**Commonwealth Edison**

Subject: Byron Station Units 1 and 2  
Braidwood Station Units 1 and 2  
Advance FSAR Information  
NRC Docket Nos. 50-454/455/456/457

This is to provide advance copies of information which will be included in the Byron/Braidwood FSAR in the next amendment. Attachment A to this letter lists the information enclosed.

FIGURE 3.9-5  
PRESSURIZER SUPPORTS

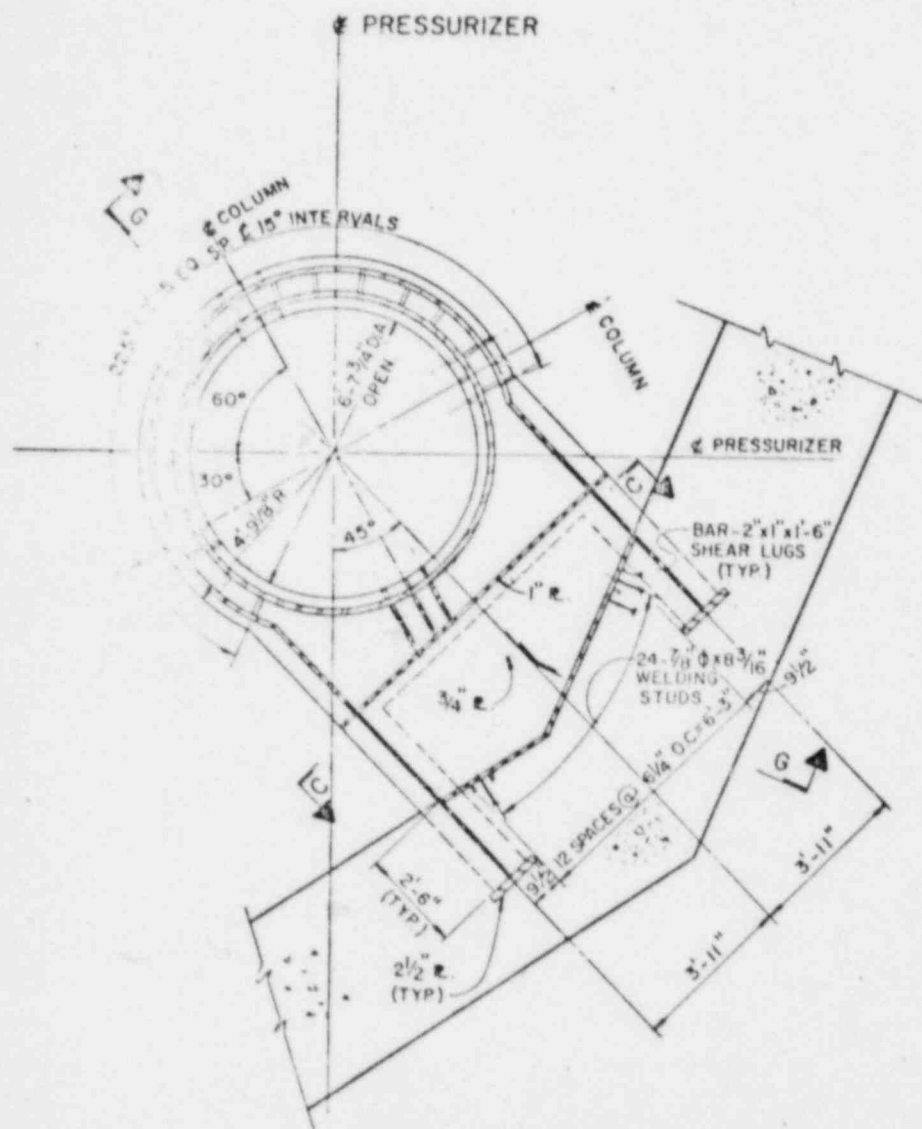
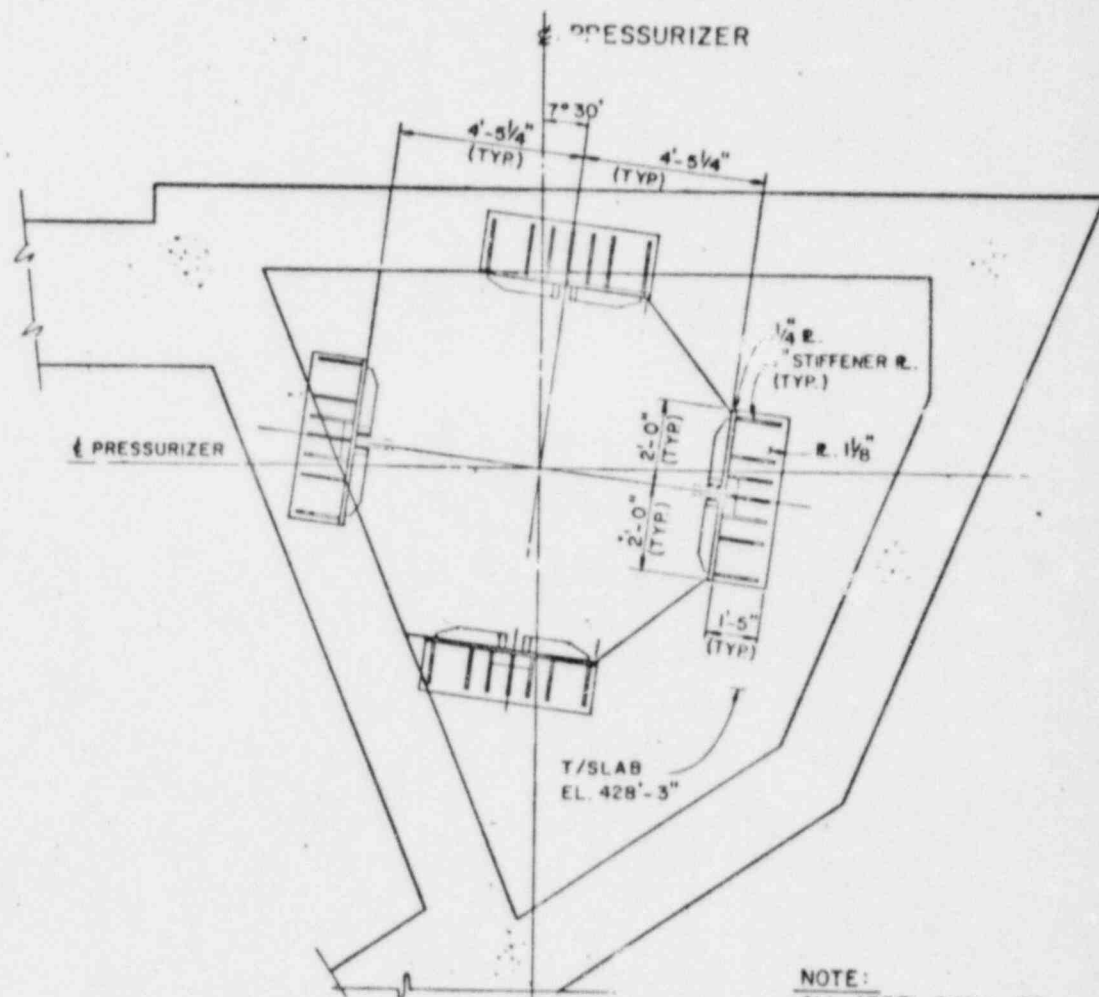
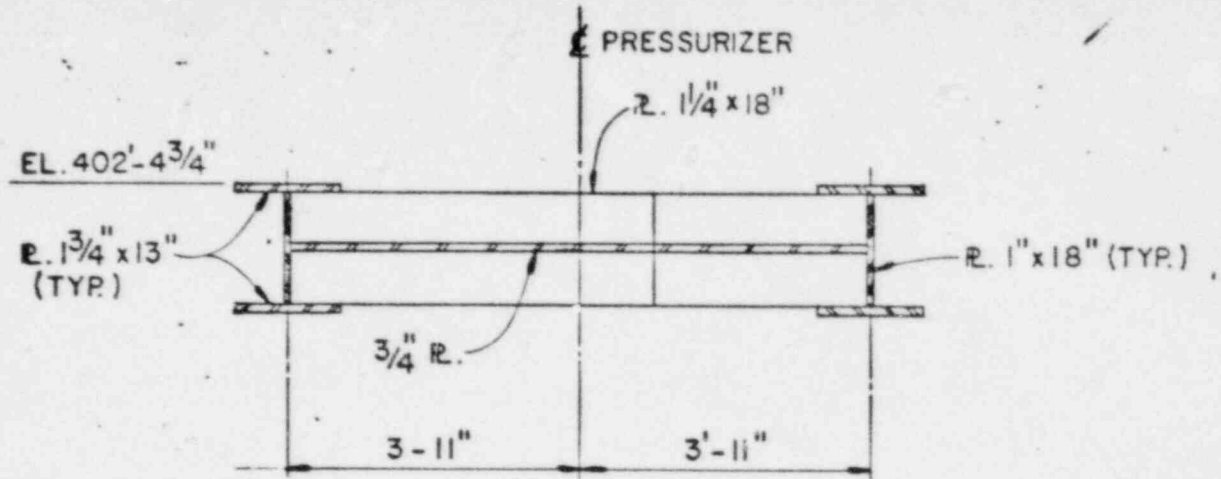
"Expand the response to clearly show how the two conservatisms incorporated in the analysis (namely, (1) using a response spectrum which is correct for the steam generator upper lateral supports and (2) using the absolute sum method of load combination) compensate for the lack of conservatism associated with the use of stresses 50% over the normal allowable limits for the faulted condition.

- (1) The general arrangement of the NSSS component support systems under reassessment are provided in Figures 3.9-4 through 3.9-10.
- (2) A plant specific analysis was performed for Byron/Braidwood, as described in revised Section 3.9.
- (3) Revised Subsection 3.9.1.4.5 describes breaks which were postulated in the RCS.
- (4) The NSSS component supports have been assessed for faulted condition loads which include the effects of subcompartment pressurization and have been found to be within the allowables described in Subsection 3.9.3.4 and Regulatory Guides 1.124 and 1.130, which include the 2/3 critical buckling stress limitations.

B/B-FSAR
Figure Q331.15-2
Hydrogen Recombiner

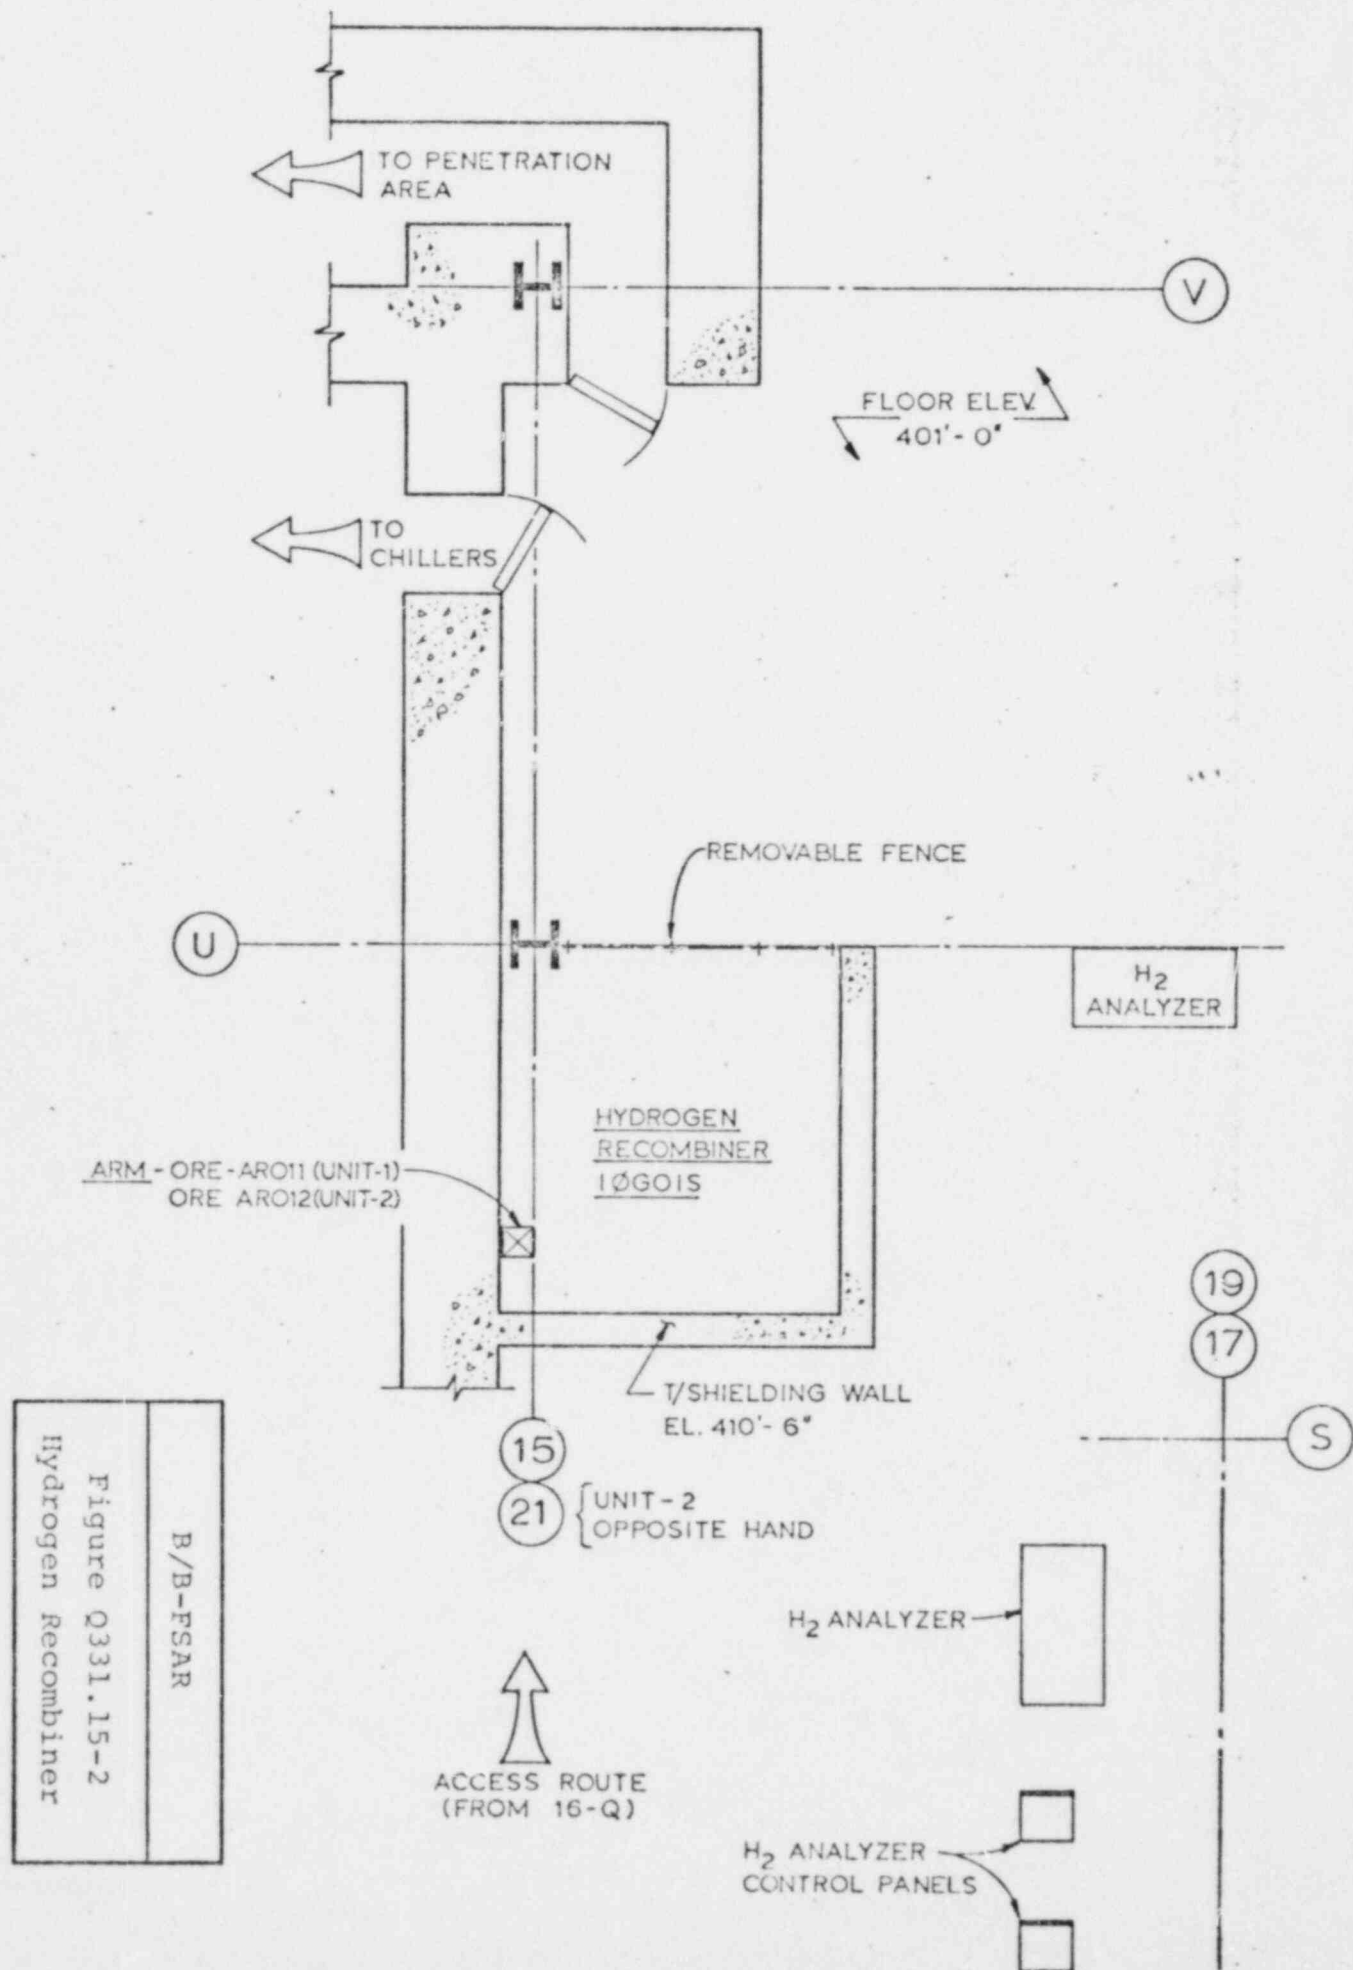
"Provide information demonstrating that adequate shielding provisions are provided to allow personnel access to activate, maintain, and operate the hydrogen recombiner system, the hydrogen monitoring system, and the post-LOCA purge system following a LOCA. (Note: Reference the response to NUREG-0737 Item 11.B.2, 'Plant Shielding Review'.)"

Figure Q331.15-2 has been revised to include the required information.
